Record of Executive Business and Chief Executive's Order

Reg. Reference: SD22A/0286 **Application Date:** 24-Jun-2022
Submission Type: Additional **Registration Date:** 06-Mar-2023
Information

Proposed Development: Demolition of 2 sheds and the construction of 30 dwellings; 1 vehicular and pedestrian link with Main Street, Newcastle; vehicle and pedestrian link with Glebe Square, Newcastle and all associated and ancillary site development works.

Location: Main Street, Newcastle, Dublin

Fig 6.4 Main Street (West) - Local Framework

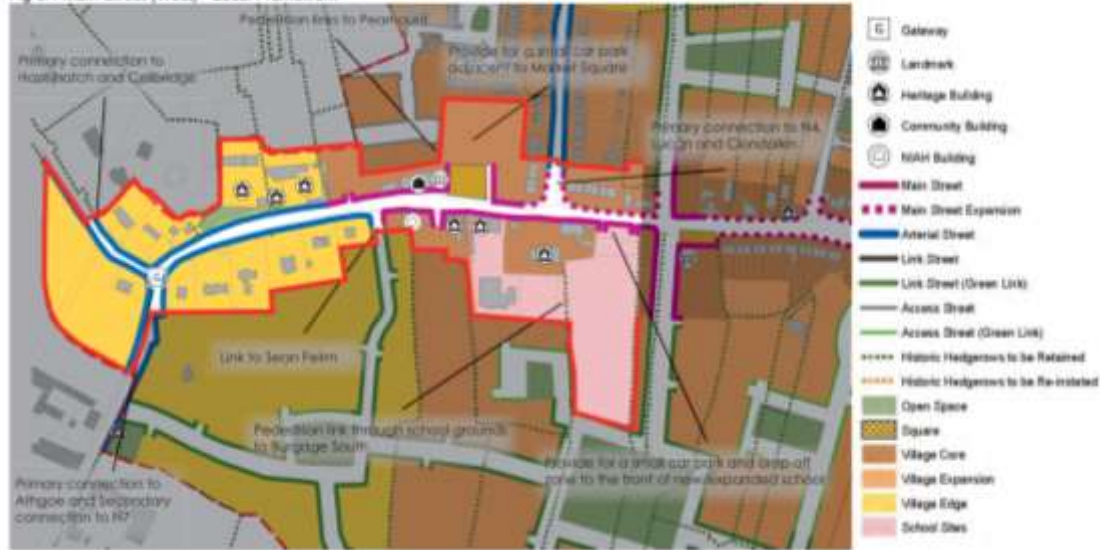
All streets are designed in accordance with the Street Hierarchy set out in the Accessibility and Movement Strategy of this Plan. It is noted that Objective PN6 requires the provision of a connection between the permitted residential development to the rear of St. Finian's Hall with Newcastle Glebe in the form of an extended vehicular cul-de-sac.

The proposed development provides for a vehicular connection to Newcastle Glebe as required by the objective. It is noted that the objective refers to an extended vehicular cul de sac. The proposed development would connect in to the Glebe, however, vehicular permeability to the Main Street is provided and a cul de sac arrangement is not provided. Some concerns are expressed by third parties in relation to the connection. The Planning Authority notes that the LAP was subject to public consultation and the connection is clear in the Plan, both in text and diagrammatically presented. Concerns are raised in relation to the implementation of the vehicular connection and sufficient legal interest. The street in Newcastle Glebe appears to be Taking in Charge, however, third parties have questioned same. Further information required.

Figure 1 road layout from SD00A/0919

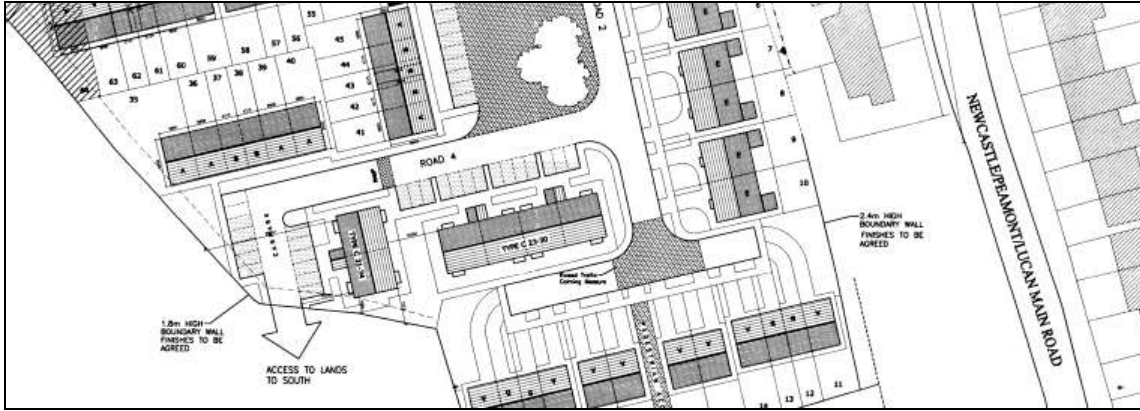
The development has two vehicular access locations and an additional pedestrian access. The link road through the development to neighbouring Glebe development matches the layout from the 2012 Newcastle LAP. The link to Newcastle Glebe was proposed in a planning application dating back to 2000, shown in Figure 1.

Figure 3 Road's layout from LAP 2012

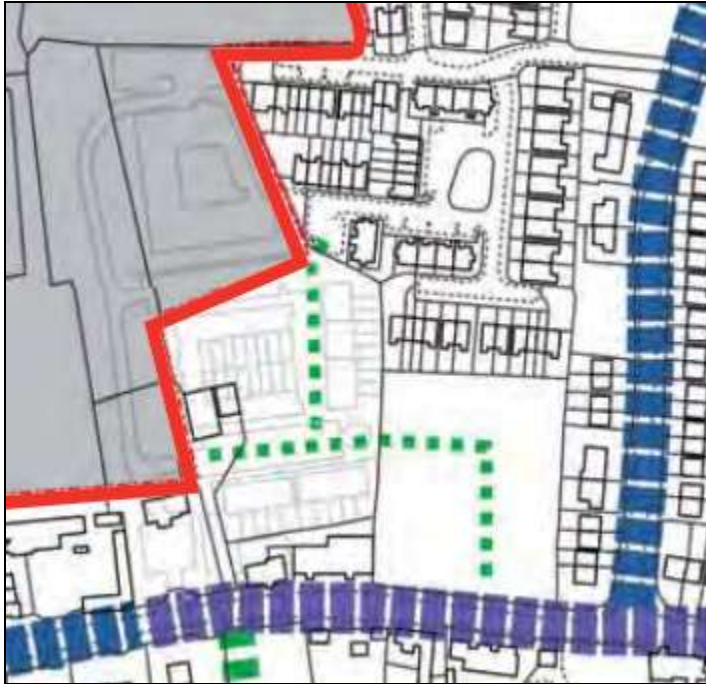
The pedestrian link to the east of the development is described as “potential” in the submission the applicant should confirm if this link is to be provided. If the link is to be provided, then the applicant should ensure a footpath is provided to the back of the parking spaces.
